Articles	Amendments
Division A Part 1	
1.1.1.1.	<p>Replace Sentences (1), (2) and (3) by the following:</p> <p>"(1) The NBC applies to the construction work performed on every <i>building</i> and facility intended for use by the public as provided in section 1.02 of Chapter I of the Construction Code (chapter B-1.1, r. 2) made pursuant to the Building Act (chapter B-1.1) (see Appendix A)."</p>

**Figure A-9.13.4.3., 9.13.4.5. and 9.13.4.7.-A**

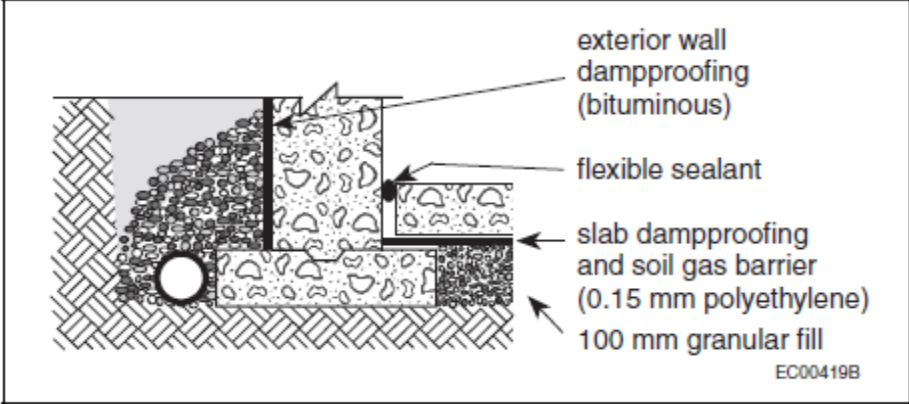
<p>Replace Appendix Notes A-9.13.4., A-9.13.4.2.(3), A-9.13.4.3. and A-9.13.4.3.(2)9b) and (3)(b)(i) by the following:</p> <p><b>"A.9.13.4. Exclusion of Soil Gas.</b> Outdoor air entering a dwelling through above-grade leaks in the building envelope normally improves the indoor air quality in the dwelling by reducing the concentrations of pollutants and water vapour. It is only undesirable because it cannot be controlled. On the other hand, air entering a dwelling through below-grade leaks in the envelope may increase the water vapour content of the indoor air and may also bring in a number of pollutants which it picks up from the soil. This mixture of air, water vapour and pollutants is sometimes referred to as "soil gas". One pollutant often found in soil gas is radon.</p> <p>Radon is a colourless, odourless, radioactive gas that occurs naturally as a result of the decay of radium. It is found to varying degrees as a component of soil gas in all regions of Canada and is known to enter dwelling units by infiltration into basements and crawl spaces. The presence of radon in sufficient quantity can lead to increased risk of lung cancer.</p> <p>The potential for high levels of radon infiltration is very difficult to evaluate prior to construction and thus a radon problem may only become apparent once the building is completed and occupied. Therefore various sections of Part 9 require the application of certain radon exclusion measures in all dwellings. These measures are</p>
